FIFTH EXPLANATION OF SIGNIFICANT DIFFERENCES (ESD)
FOR THE
NEW BEDFORD HARBOR SUPERFUND SITE
UPPER AND LOWER HARBOR OPERABLE UNIT 1 (OU1)
NEW BEDFORD, MASSACHUSETTS
JULY 2015

EPA REGION 1

New Bedford Harbor Superfund Site (Site)
Upper and Lower Harbor Operable Unit 1 (OU1)
Bristol County, Massachusetts

Figure 21a - Conceptual locations of upper harbor CDFs A, B and C
 New Bedford Harbor Superfund Site, ROD 2

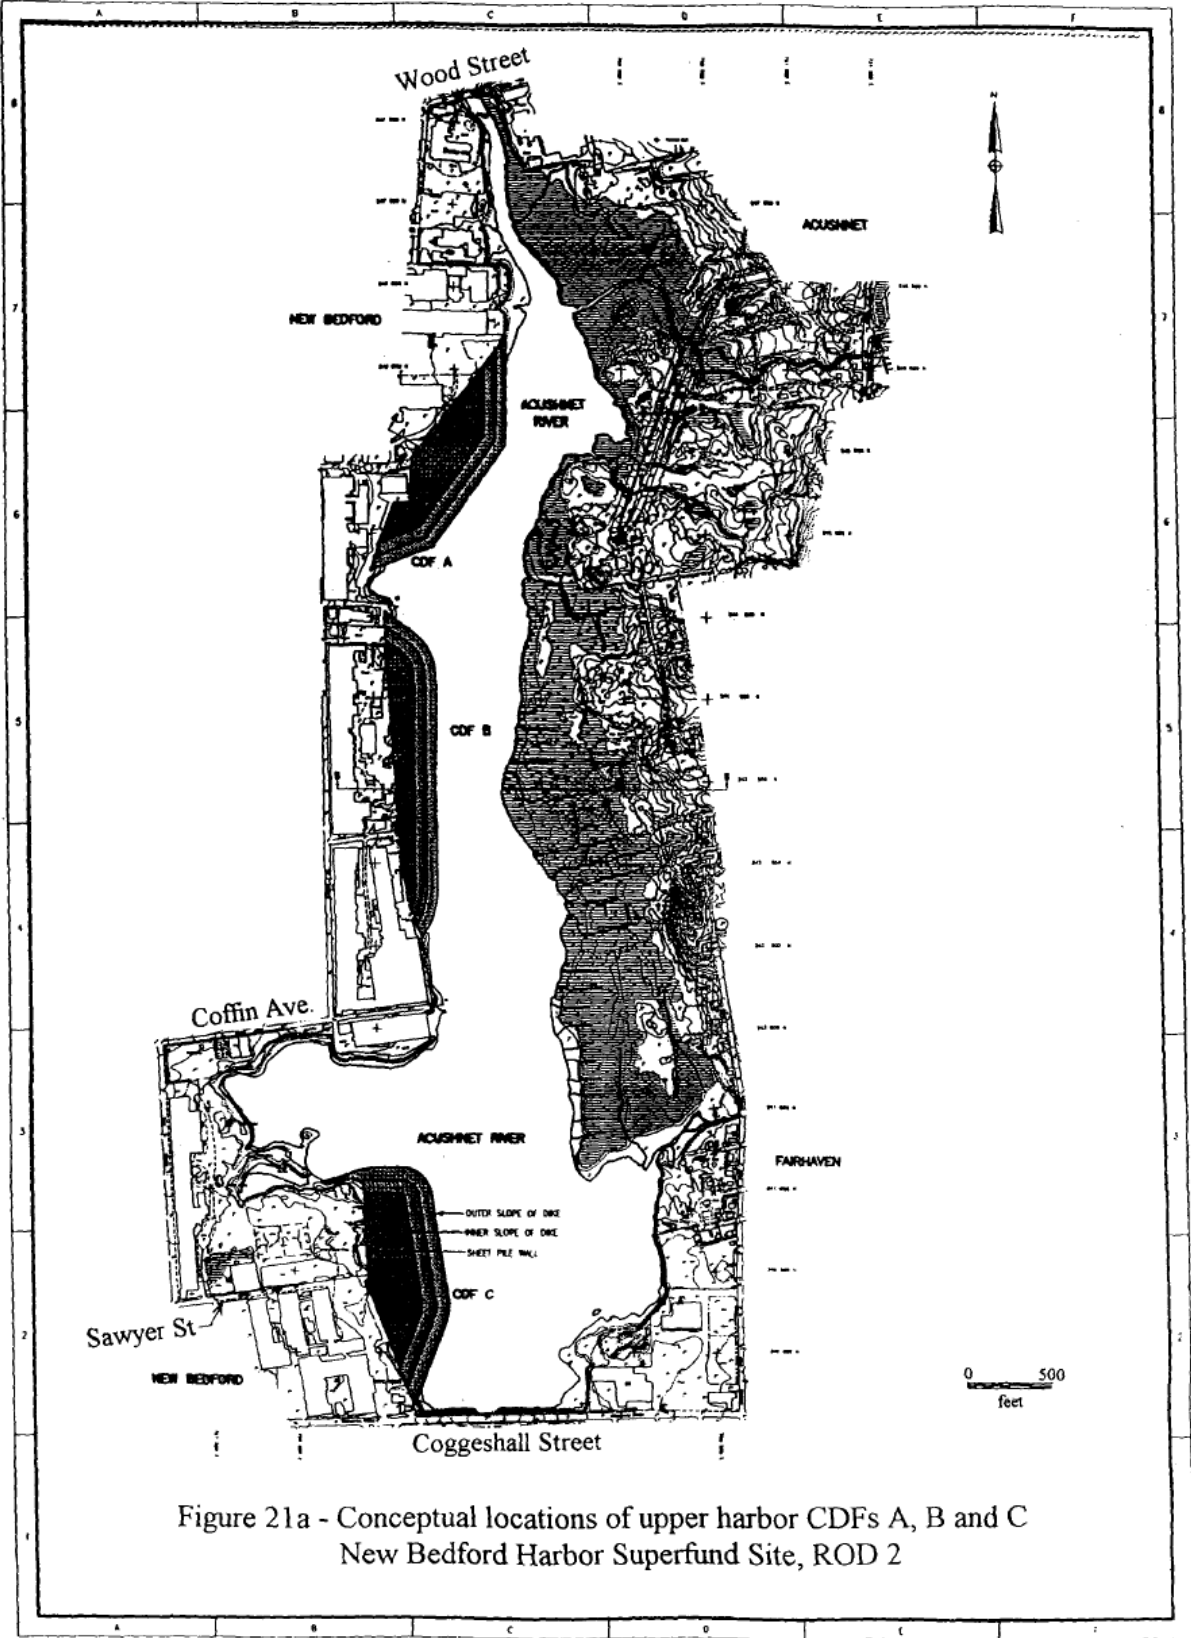
Through this fifth ESD to the OU1 ROD, EPA has modified the remedy for the Upper and Lower Harbor by eliminating the construction of the planned CDFs A, B and modified-C (see discussion in Section II.C, below, regarding modification of the conceptual design of CDF C) and selecting off-site disposal for the sediment slated for disposal in those planned confined disposal facilities. As conceptually planned under the OU1 ROD, CDFs A, B and C were to be shoreline structures (see attached Figure 21a from the OU1 ROD). Note that CDF C was planned for construction at and around the location of the pilot study CDF (see discussion in Section II.A, below, regarding the creation and use of the pilot study CDF). As such, the Pilot CDF is located within the footprint of the conceptual location of CDF C.

Considering the potential effectiveness and implementability concerns associated with CDFs, the longer timeframe needed for CDF construction and utilization, and the higher estimated cost of CDF disposal as compared to off-site disposal, EPA, through this fifth ESD, is eliminating CDFs A, B and modified-C as a disposal element of the OU1 remedy and instead selecting off-site disposal for the approximately 175,000 cubic yards of *in situ* contaminated sediment currently slated to be disposed of in CDFs A, B and modified-C.

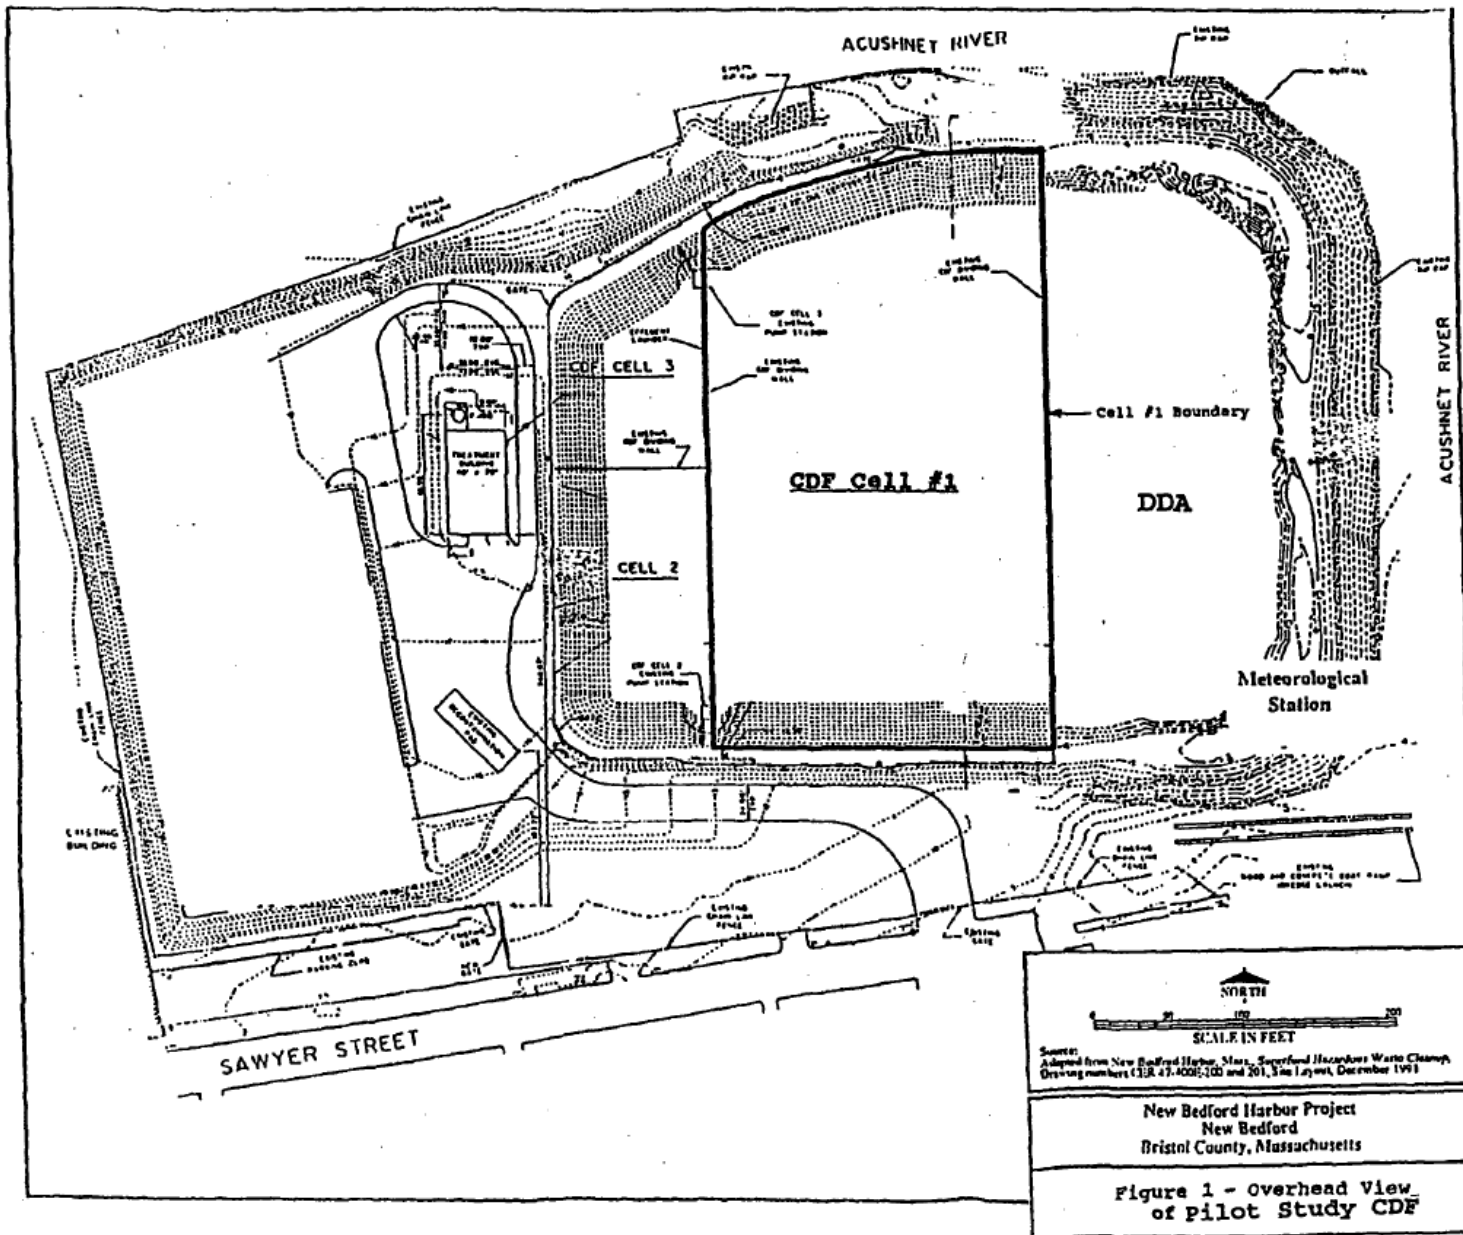
Groundwater and air monitoring performed at the Pilot CDF since 1992, along with groundwater modeling, demonstrate that PCBs are not migrating from the Pilot CDF area. See attached Figure 1 from the Sawyer Street Semi-annual Groundwater Monitoring Technical Memorandum showing location of groundwater monitoring wells. As noted in ESD1, underlying the Pilot CDF is a clay layer sandwiched between the Pilot CDF contents and the underlying sands. The clay layer acts as a naturally impermeable barrier to the movement of contaminants from the area. The constructed dike serves as three sidewalls of the Pilot CDF. Due to the type and quantity of materials used to construct the dike, these sidewalls have moderate permeability with an estimated hydraulic conductivity of 3 ft/day. Although these sidewalls are not impermeable, the over 20 years of groundwater monitoring data demonstrate that PCBs are not migrating. The sheet pile wall that serves as the sidewall separating the Pilot CDF from Cell #1 is impermeable. Consistent with the process described in ESD1, since the monitoring and modeling performed to date of the Pilot CDF confirm that PCBs are not migrating from the area and given the subsurface and sidewall features, the Pilot CDF is made an element of the final remedy.
